**ADDENDUM NO. 1**  
(Issued March 12, 2026)

**STORM DAMAGE REPAIRS TO ALDERPOINT ROAD (F6B165)**  
**AT PM 42.00 - 42.30**  
**PROJECT NO.: ER-32L0(124)**  
**CONTRACT NO.: 217213**

COUNTY OF HUMBOLDT DEPARTMENT OF PUBLIC WORKS
STORM DAMAGE REPAIR ALDERPOINT ROAD PM 42.00-42.30
STAGING/STOCKPILE LOCATIONS AND QUANTITIES

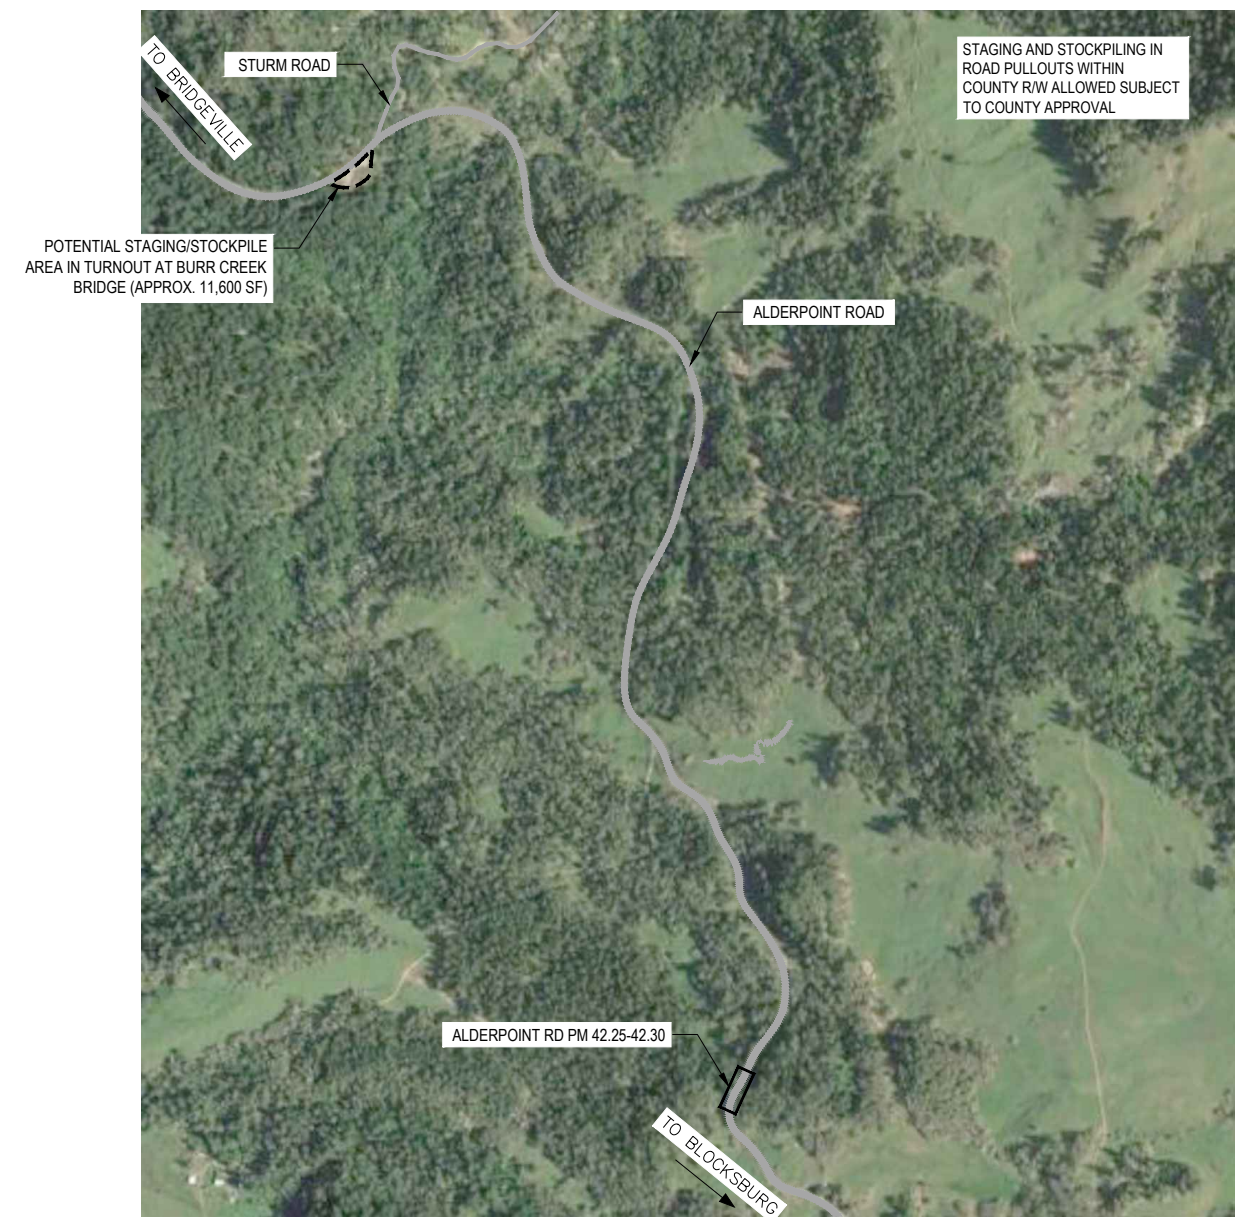
7. **Replace the following sheets of the project plans with the attached revised sheets** (*general description of revisions in parenthesis*):
  - a. Sheet 2 – Staging/Stockpile Locations and Quantities (*updated items and quantities*)
  - b. Sheet 10 – PM 42.00 Drainage and Utilities (*updated storm drainage system*)
  - c. Sheet 11 – PM 42.00 Drainage Profiles (*updated storm drainage system*)
